SERVICE No. 200 BULLETIN

Piper Aircraft Corporation

SUBJECT: Replacement of Oil Radiator Lines

MODELS AFFECTED: PA-23-250 Aztecs, Serial Nos. 27-2 to 27-5 inclusive, 27-7 to 27-48 inclusive, 27-50 to 27-133 inclusive, 27-135 to 27-425 inclusive and all Navy UO-1 airplanes.

SERVICE BULLETIN
No 200

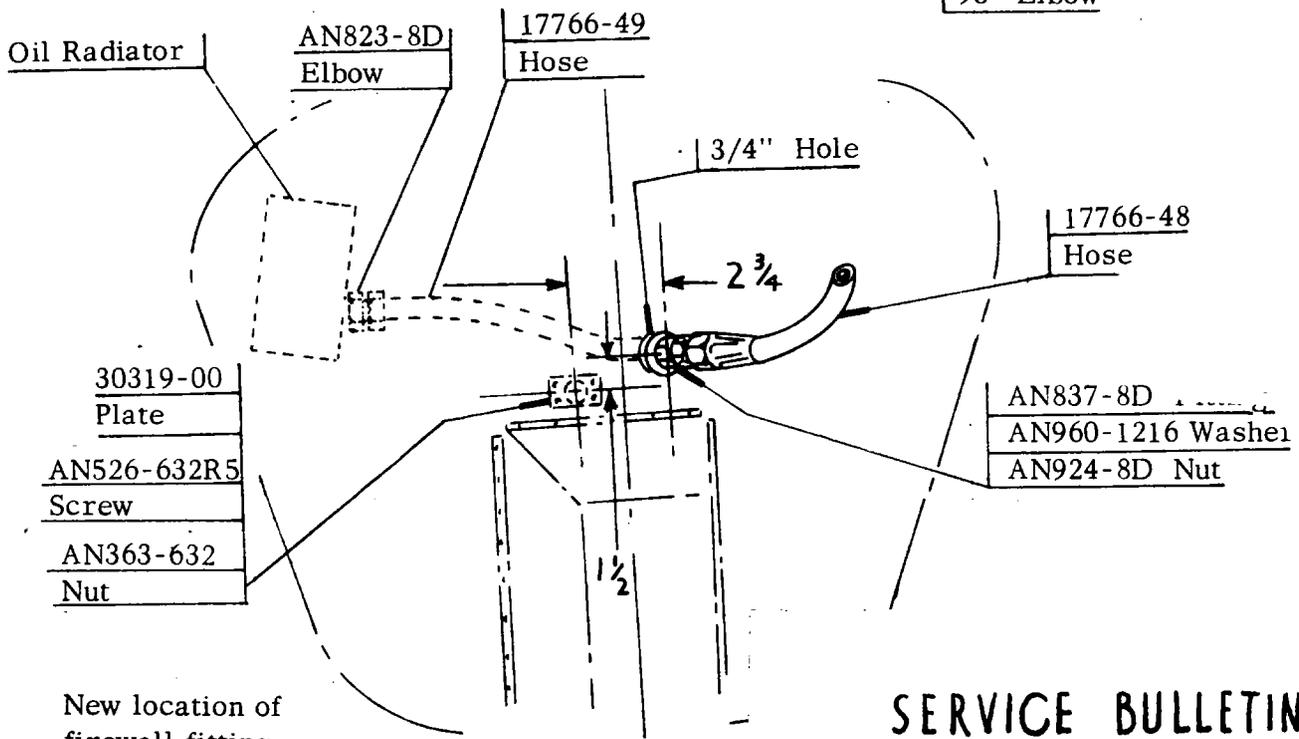
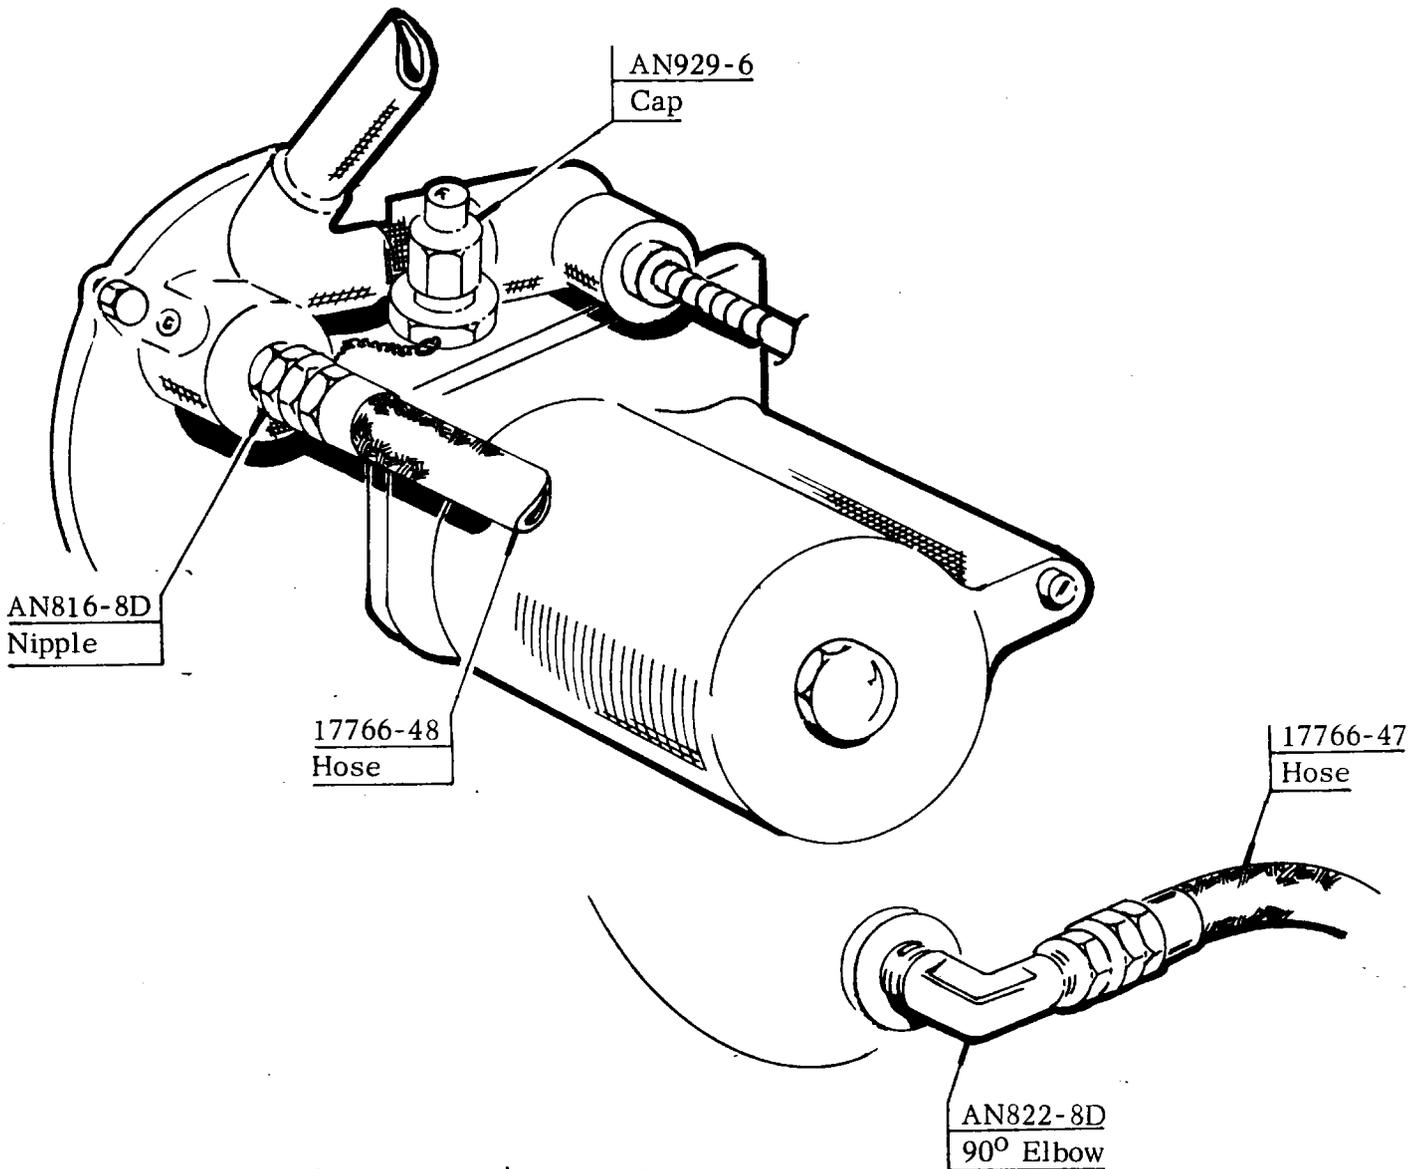
We have received a few reports from the field indicating that ruptures have occurred in the oil radiator lines at the oil radiator fitting.

It is requested that, in order to prevent this condition from occurring, the three oil lines on each engine - engine to oil radiator and return lines - be replaced. The new oil lines are of a slightly larger internal diameter.

New location of
firewall fitting.
Right engine only.

Kit No. 754 387 consists of six (6) oil lines and necessary fittings to modify each engine. A self-addressed card is enclosed with each kit. This card is to be returned to the factory indicating date of compliance. The sketch on the reverse side of this bulletin may be referred to for details of installation.
